## JEFFERSON FEDERAL ADDITION TO MONTLIMAR SUBDIVISION, RESUBDIVISION OF LOTS 1 AND 2, OF THE RESUBDIVISION OF LOT 1

## JEFFERSON FEDERAL ADDITION TO MONTLIMAR SUBDIVISION, RESUBDIVISION OF LOTS 1 & 2, OF THE RESUBDIVISION OF LOT 1

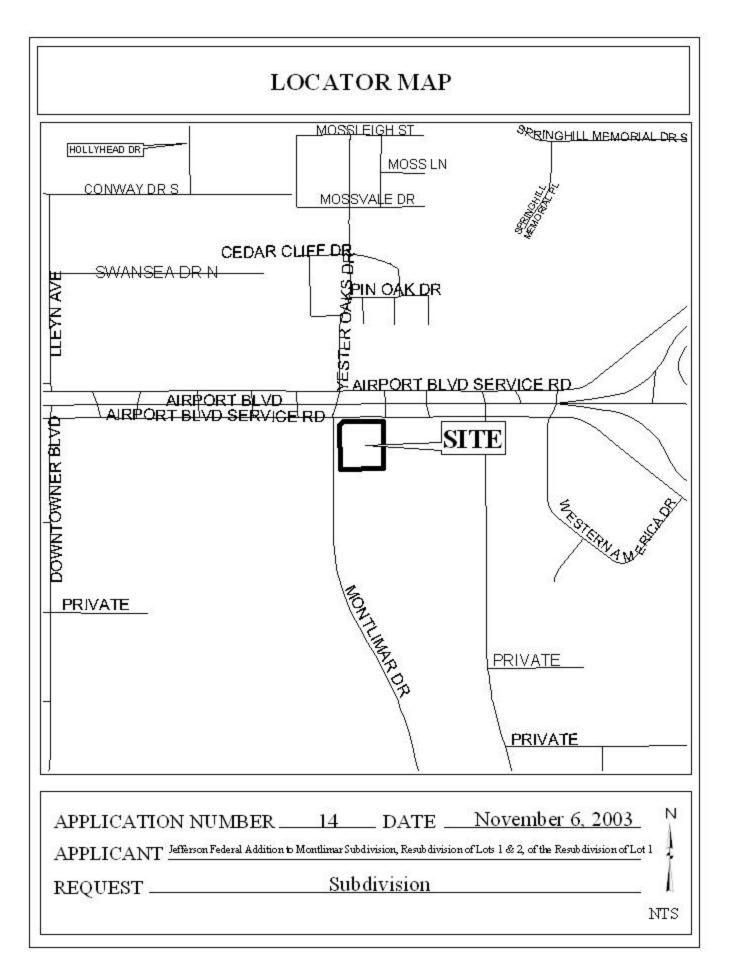
<u>Engineering Comments:</u> Must comply with all stormwater and flood control ordinances. Any work performed in the right-of-way will require a right-of-way permit.

<u>Traffic Engineering Comments:</u> Driveway numbers, size, location and design to be approved by Traffic Engineering and conform to AASHTO standards.

The site fronts Airport Boulevard Service Road, a planned major street as illustrated on the Major Street Plan and has an existing right-of-way in compliance with the Plan. Service Roads are an approved method of access management, therefore, a restriction on curb cuts is not necessary; however, direct access to Montlimar Drive should be denied to eliminate potential "cut through" traffic. Additionally, the placement of a note on the final plat stating that the site is allowed to maintain existing curb cuts, but redevelopment of the site will require curb cut approval by Traffic Engineering, should be required.

The plat meets the minimum requirements of the Subdivision Regulations and is recommended for Tentative Approval subject to the following conditions: 1) the placement of a note on the final plat stating that direct access to Montlimar Drive is denied; and 2) the placement of a note on the final plat stating that the site is allowed to maintain existing curb cuts, but redevelopment of the site will require curb cut approval by Traffic Engineering.
